Central – Wan Chai Bypass – Tunnel (Slip Road 8 Section)

As-Built Drawings of Noise and Visual Mitigation Measures
in the deposited Additional Mitigation Plan for Slip Road 8
(under Condition 2.12 of Environmental Permit No. EP-482/2013/A)

As-built Drawings of the Landscape and Visual Mitigation Measures for Slip Road 8

EPD's comment via memo dated 19 October 2018 ref. (22) in EP2/H4/S3/15 Pt.47	<u>Responses</u>
<p>Wan Chai Development Phase II – Central-Wan Chai Bypass at Wan Chai East</p> <p><u>EP Condition 2.12: Submission of As-built Drawings of the Noise and Visual Mitigation Measures in the Deposited Additional Mitigation Plan for Slip Road 8</u></p>	
<p>It is noted that this “As-built- drawings” is the same as the revised plan “Appendix C” under C.2.16 of FEP 10/364/2009/B submitted by China State Construction Engineering (HK) Ltd on 30.8.2018. Since C.2.12 of EP-482/2013/A is in conjunction with C.2.16 of FEP 10/364/2009/B, our comment on Appendix C under C.2.16 of FEP 10/364/2009/B, as extracted below, is also applicable to this submission:</p> <p>I. The proposed planting of <i>Bambusa vulgaris</i> is an acceptable alternative measure, subject to the agreement from the

SKETCH NO. 60095653/72/SK0750

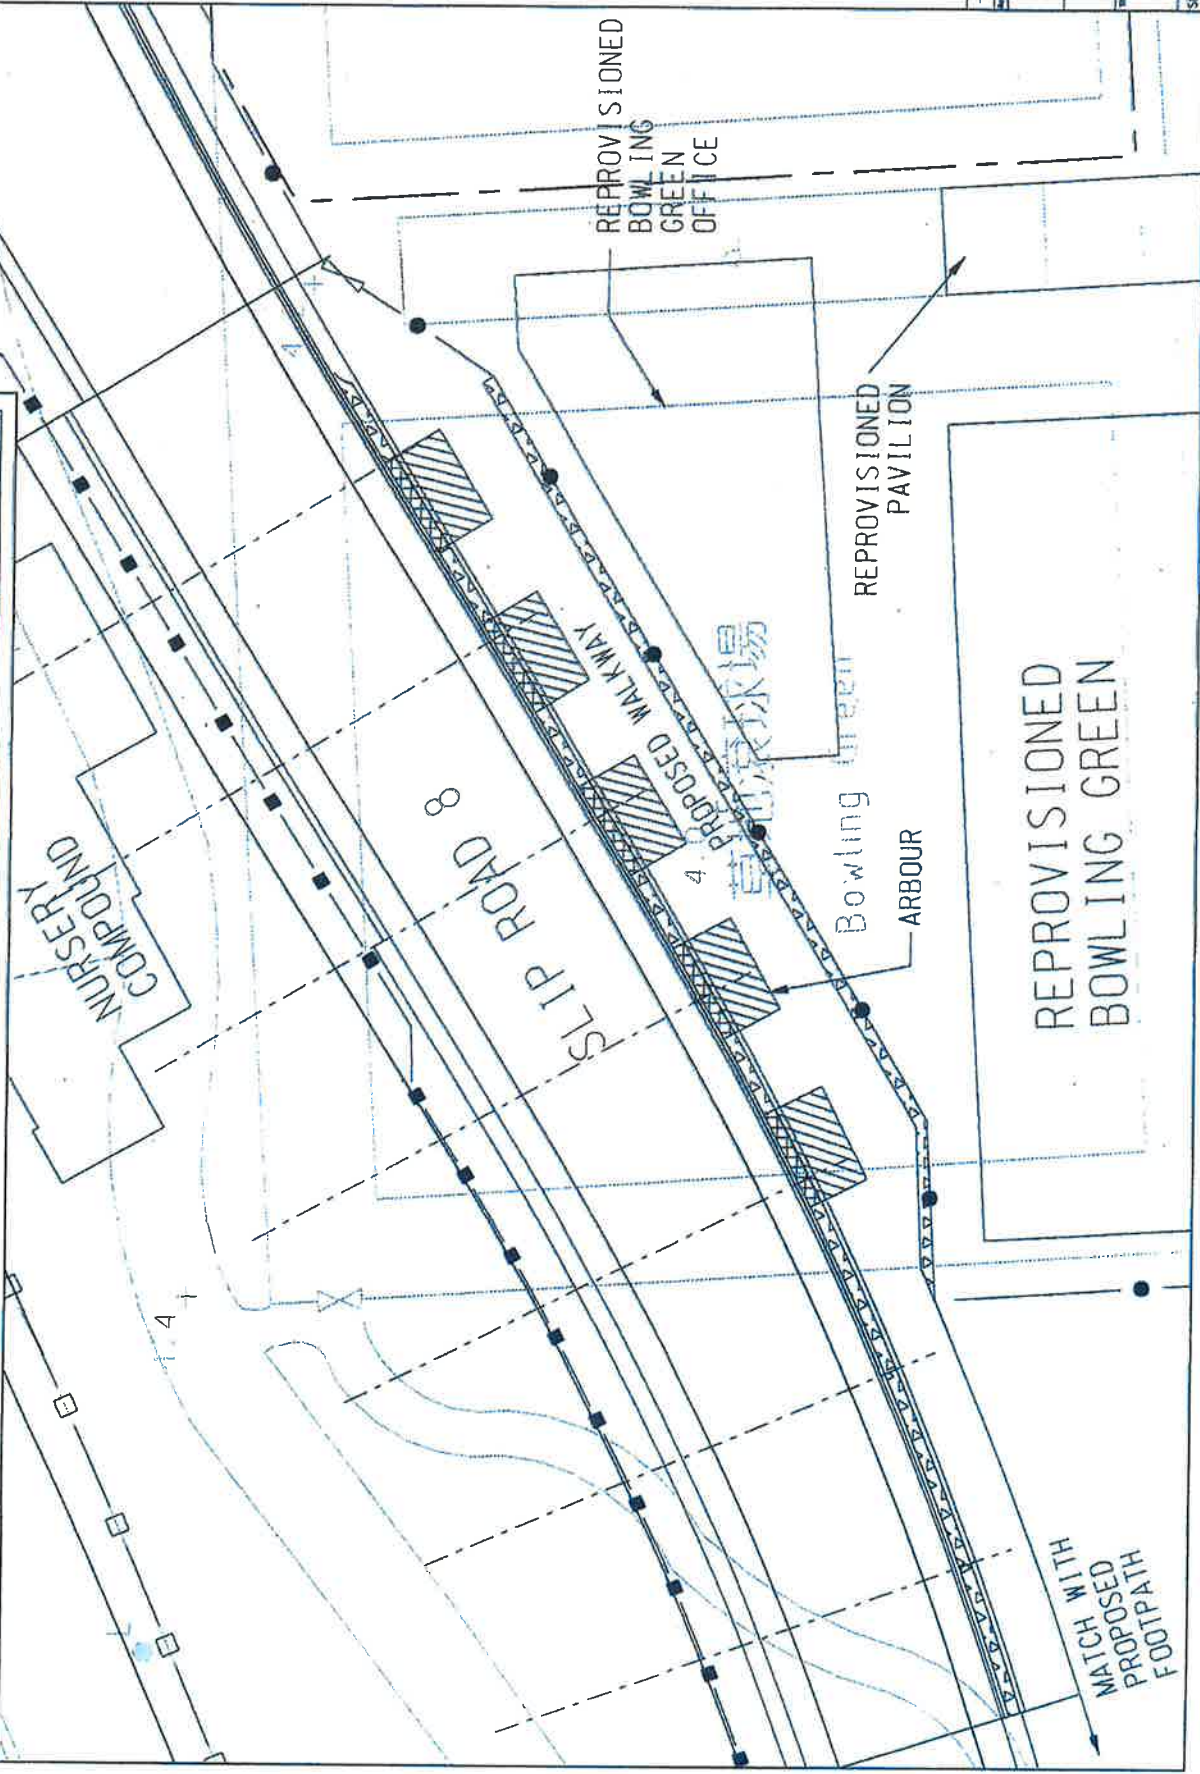
As discussed in the VPMO Meeting yesterday, please advise whether you have any comment on the proposed planting plan for the additional walkway as shown on the attached Sketch No. SK0750.

Please also advise your comment on the proposed relocation of 12 no. transplanting trees as shown green on the attached Sketch No.SK0742 in order to maintain the existing footpath system in the Park.

Please be advised that we have no adverse comment for the proposed planting plan for the additional walkway and the proposed location of 12 nos. transplanting trees.

SKETCH NO. 60095653/T2/SK0721D SCALE 1:500(A3)

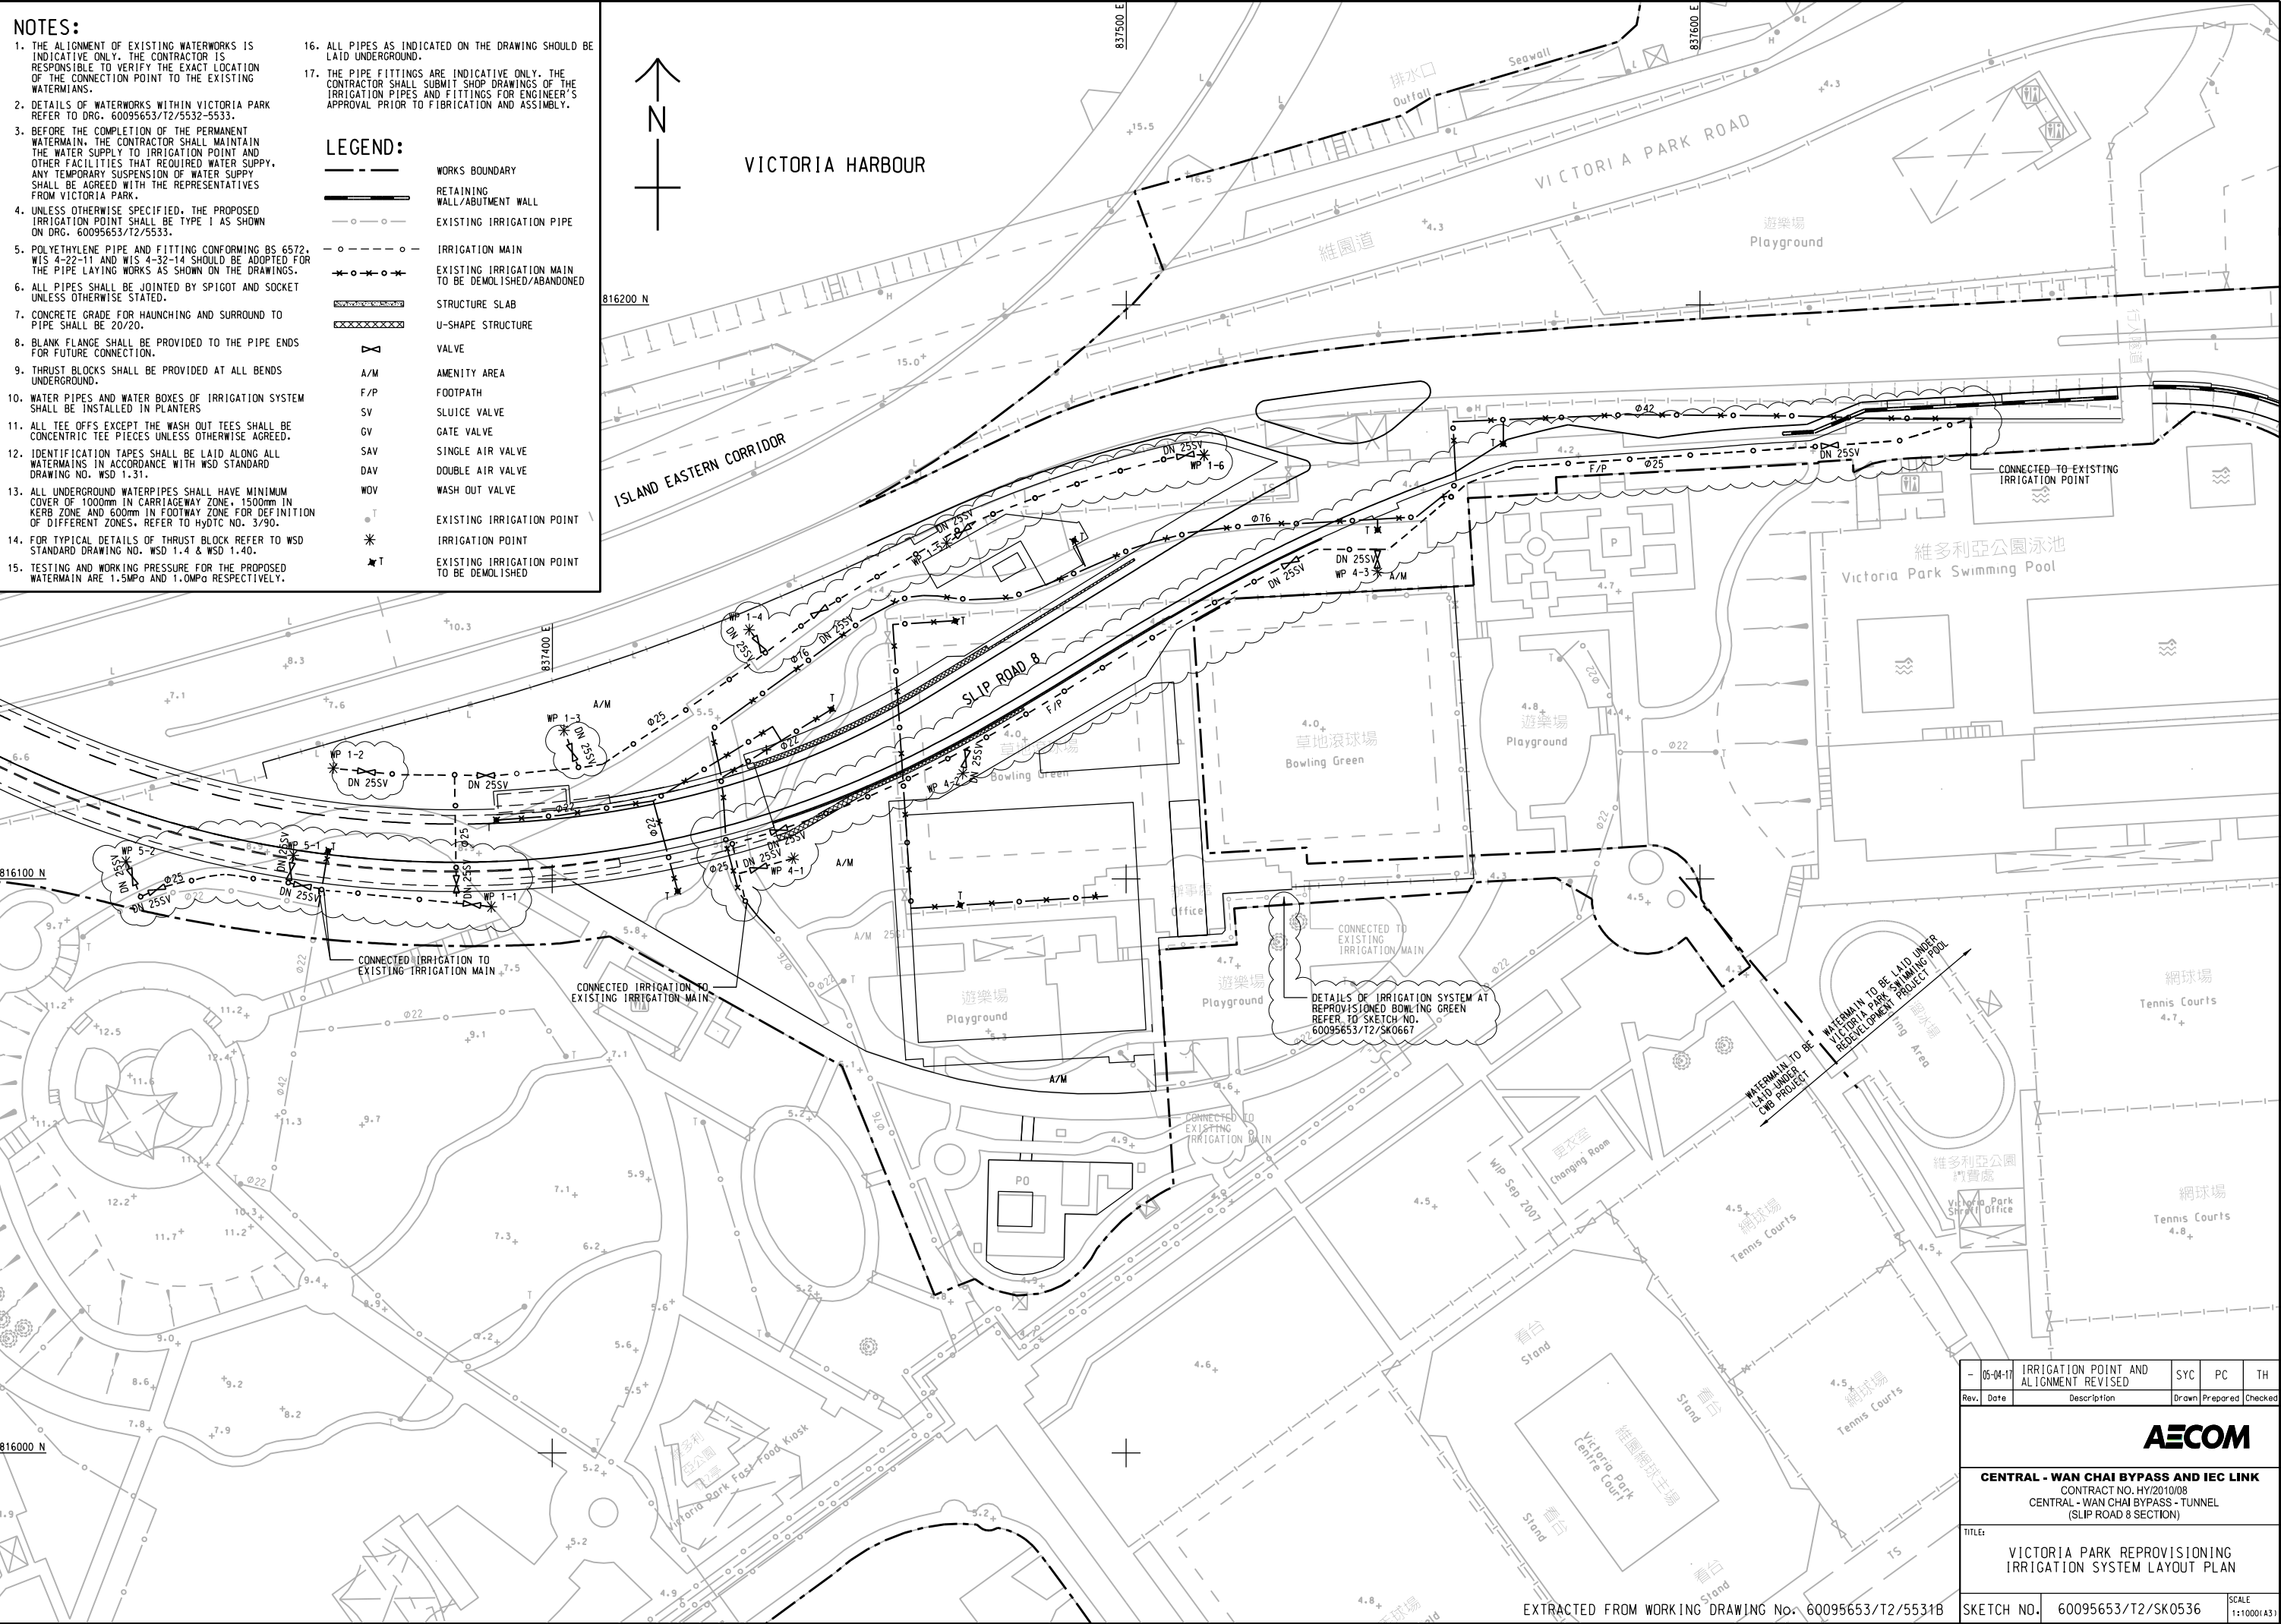
<p>II. Details to support the proposed bamboo planting, e.g. width and depth of soil medium and irrigation arrangement should be indicated in the section A-A drawing.</p>	<p>For the width of the soil medium please refer to the site sketch as attached in Annex 2. For the depth of the soil medium, it varies from 1.7m to 4.5m. For the irrigation arrangement layout and details of waterpoint, please refer to the site sketch as attached in Annex 3.</p>
